NUREG/CR-1278

Handbook of Human Reliability Analysis with Emphasis on Nuclear Power Plant Applications

Addendum #1 to NUREG/CR-1278, August 1983

Following are some corrections to the above document, listing the page (p) and paragraph (para) numbers. Understandable typos are excluded. Some updating of references is included.

Figure 12-3 Initial-screening model of estimated HEPs and UCBs for diagnosis within time T of one abnormal event by control room personnel (based on Oswald et al, 1982).

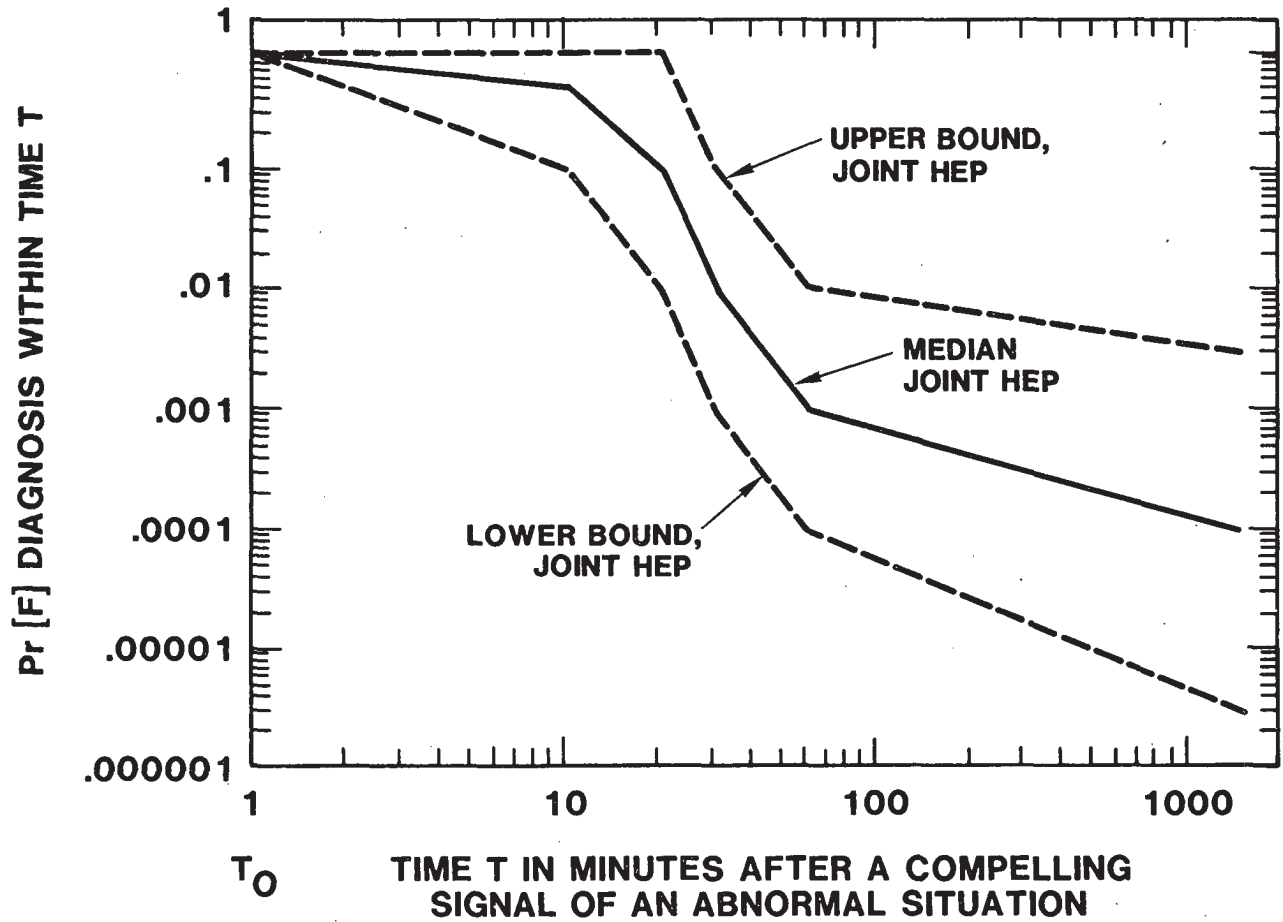
- 12-8,4 Line 7: ... emergency operating procedures ...
- 12-12,3 Line 4 & 5: ... Wreathall (1981, p 104, and 1982), ...
- 12-13 Table 12-3: The 3 lines in the figure should meet at the 1.0 Pr[F] rather than at the .9 HEP. Also, the 1 (e.g., HEP of 1.0) is incorrectly placed; it should be in the same relative position above the .9 HEP as is the .1 HEP above the .09 HEP. The Pr[F] values for the lower bound and median HEPs at 10 minutes are correct. The Pr[F] values for the upper bound HEP at 20 minutes should be 1.0.

Figure 12-4 Nominal model of estimated HEPs and UCBs for diagnosis within time T of one abnormal event by control room personnel.

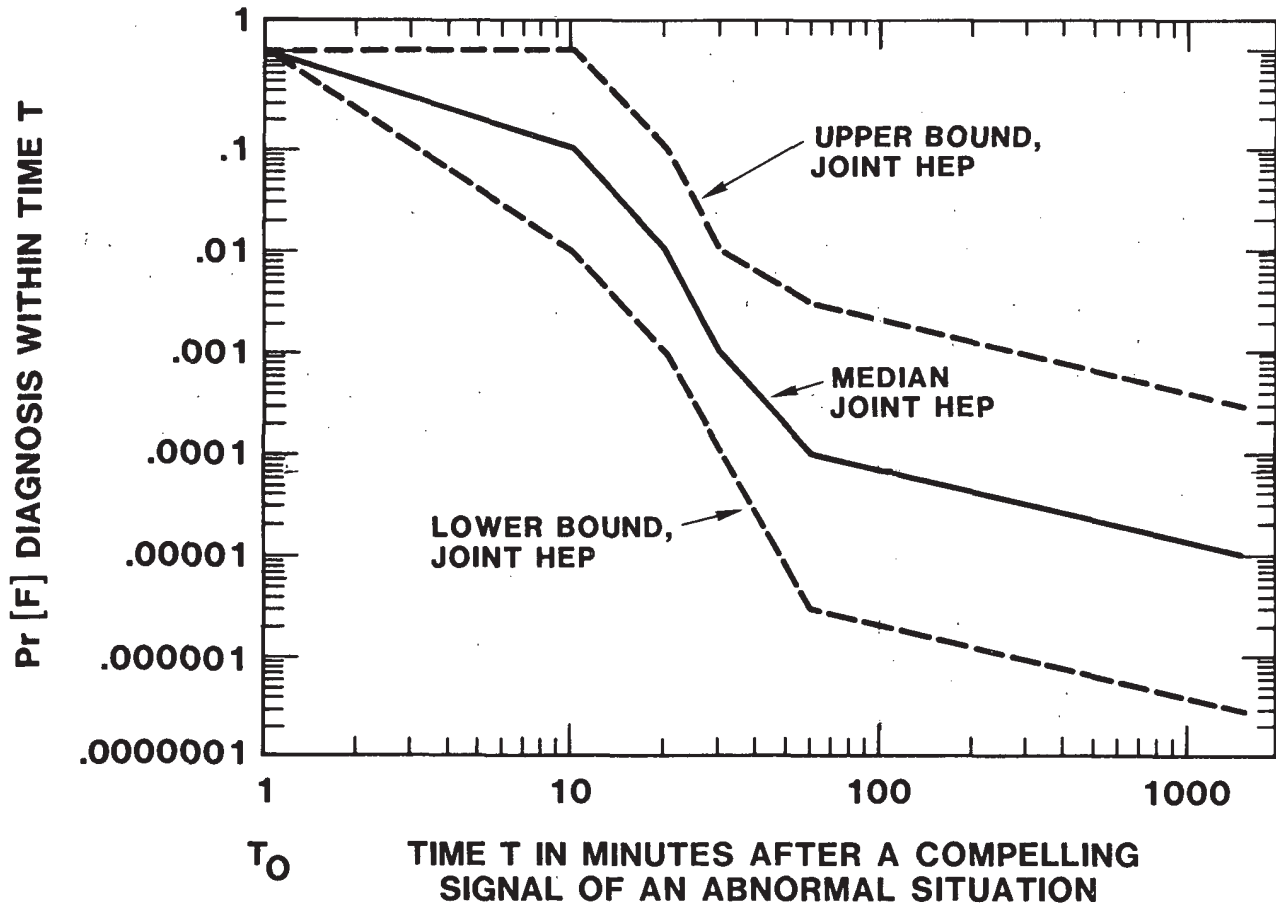
- 12-20 Table 12-4: The 3 lines in the figure should meet at the 1.0 Pr[F] rather than at the .9 HEP. Also, the 1 (e.g., HEP of 1.0) is incorrectly placed; it should be in the same relative position above the .9 HEP as is the .1 HEP above the .09 HEP. The Pr[F] values for the lower bound and median HEPs at 10 minutes are correct. The Pr[F] values for the upper bound HEP at 10 minutes should be 1.0.

Figure 20-1 Search scheme for use of Chapter 20 tables (p 1 of 3).

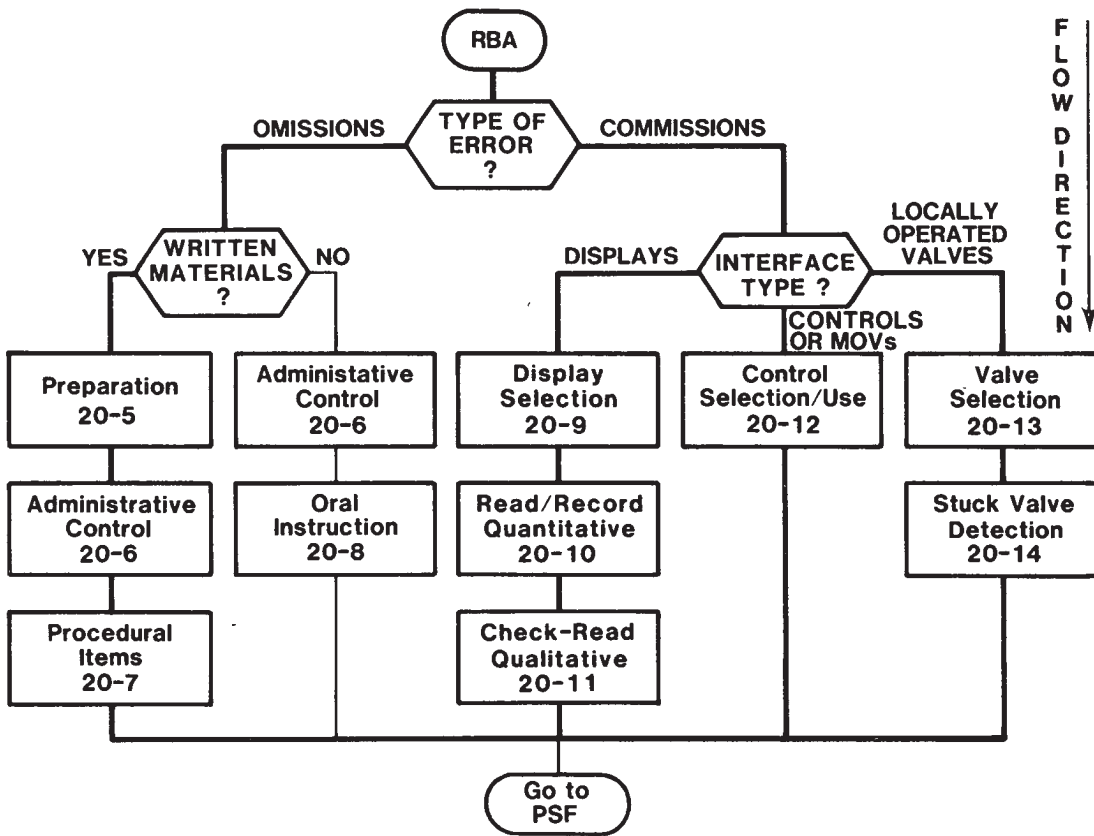
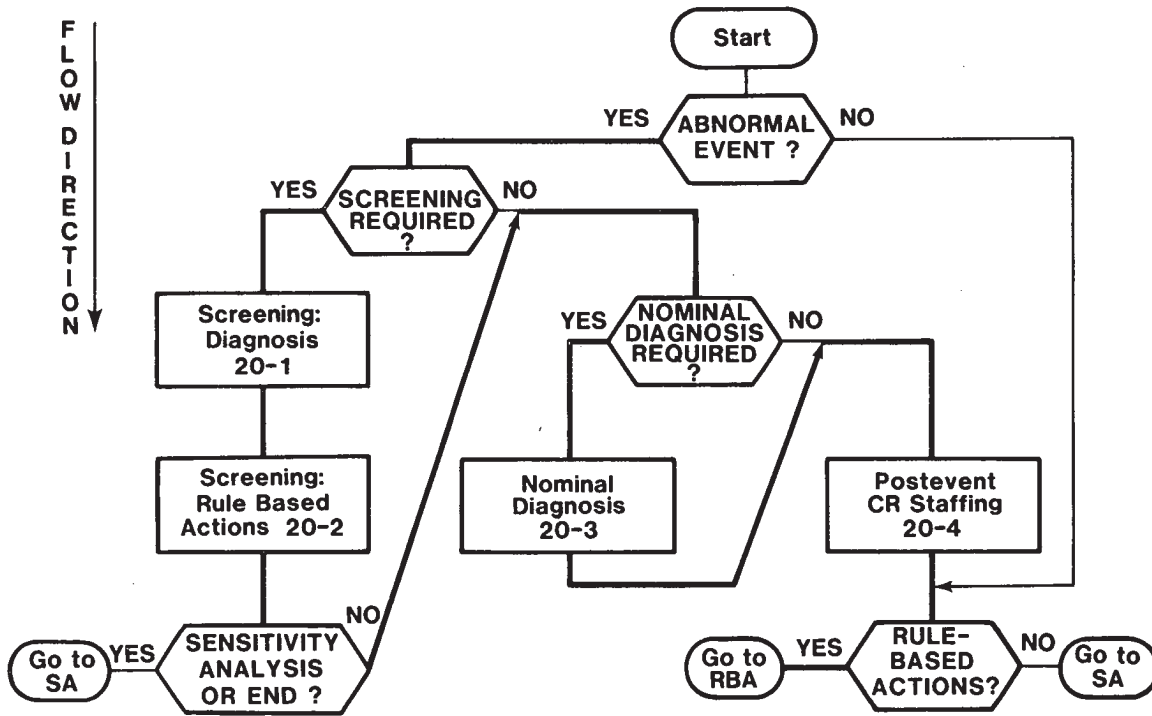
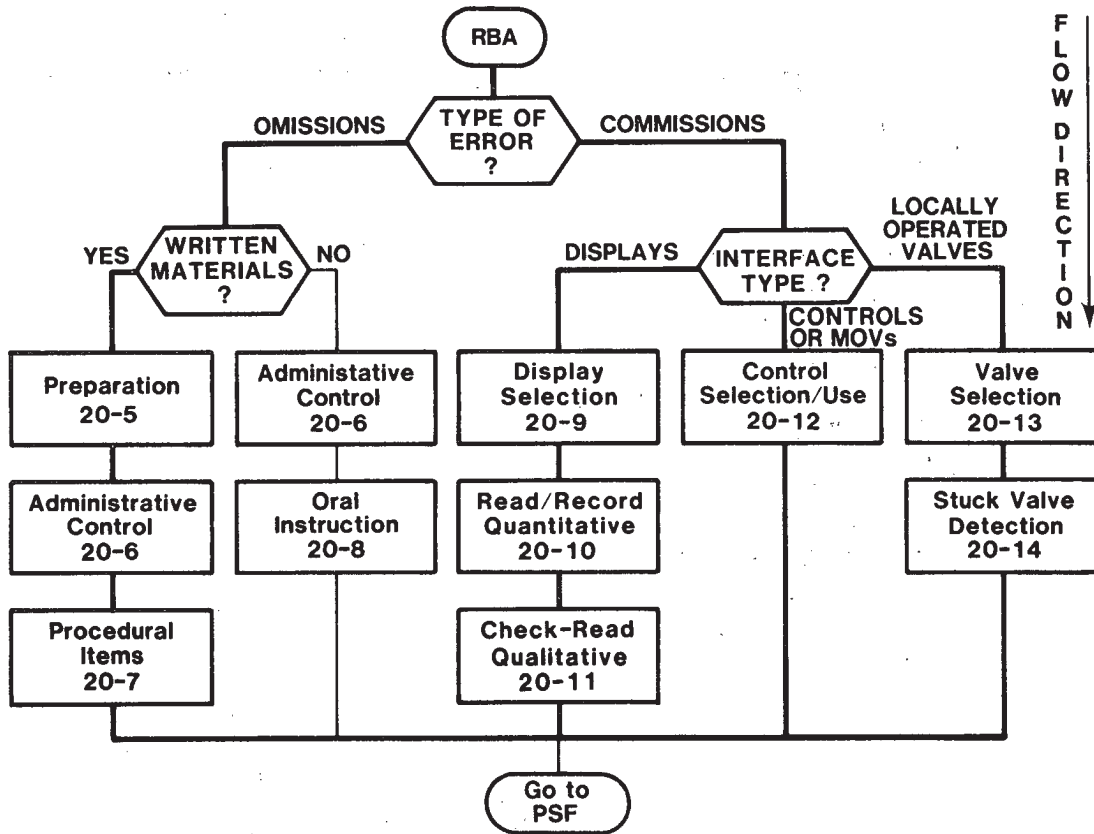
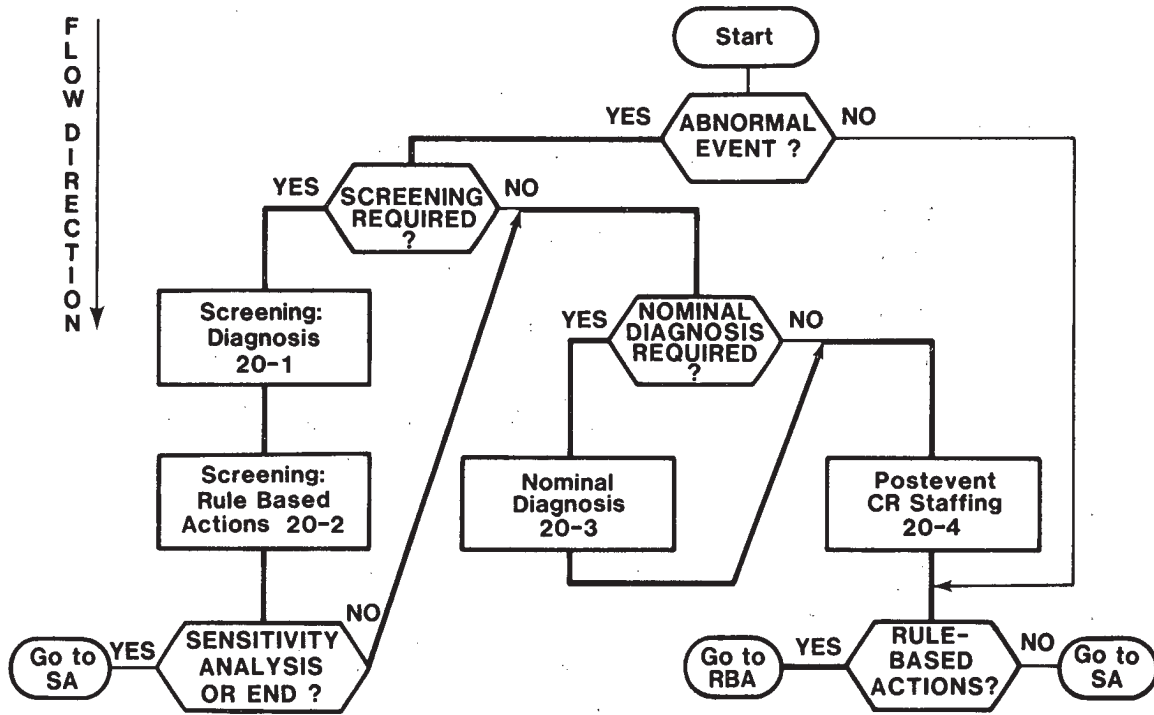
- 20-3 Figure 20-1 (p1 of 3): Insert a "Screening Required?" hexagon in the No line following the "Abnormal Event?" hexagon. The YES and NO lines from the new hexagon go to the "Rule-Based Actions?" hexagon. Insert a "Decide on Screening Rules" box in the YES line.
[This change is necessary because many PRAs require some form of screening for pre-accident situations.]

Figure 20-1 Search scheme for use of Chapter 20 tables (p 2 of 3).

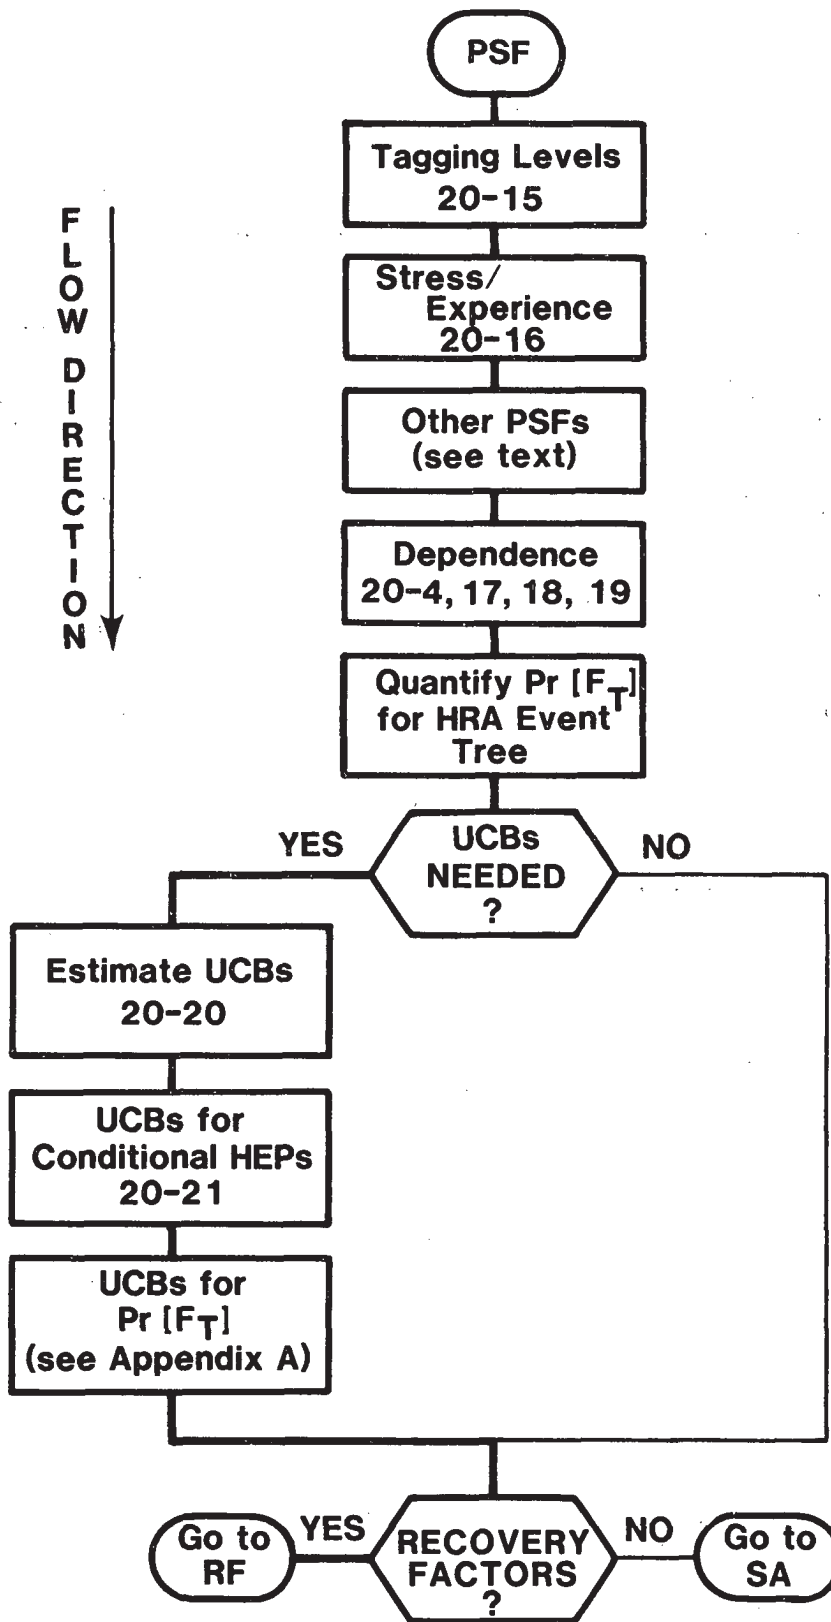
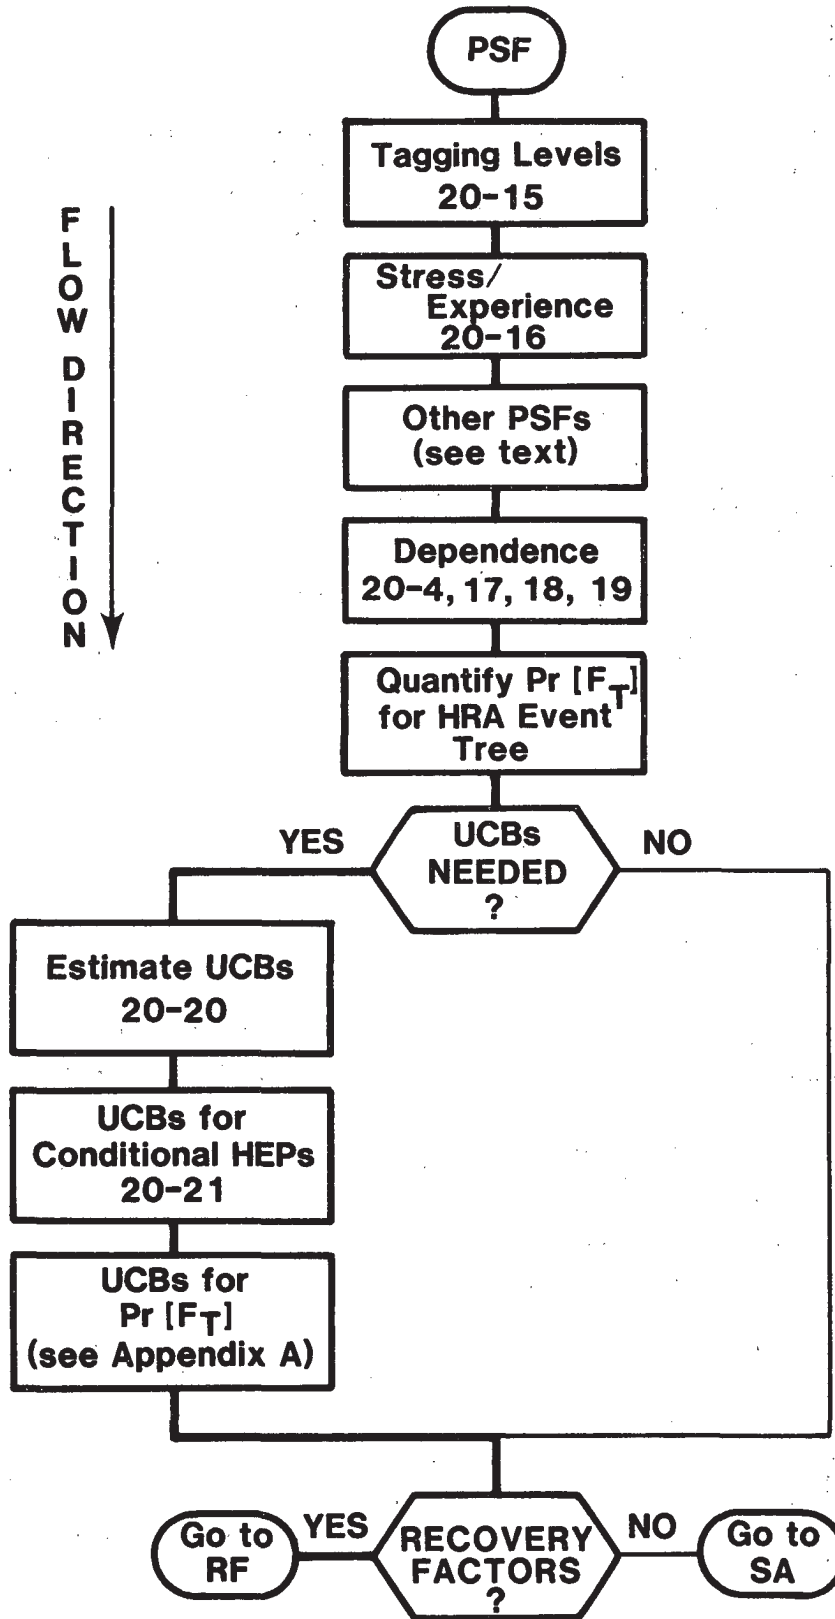
- 20-4 Figure 20-1 (p2 of 3), "Other PSFs" box: Other PSFs (see text, especially pp 3-14, -17,- 19,- 72, and 17-7)
- 20-6,5 Item (2), line 7: ... Assume YES. (Note: Screening may also be required for non-abnormal tasks, as shown in the NO path following the ABNORMAL EVENT? hexagon.)
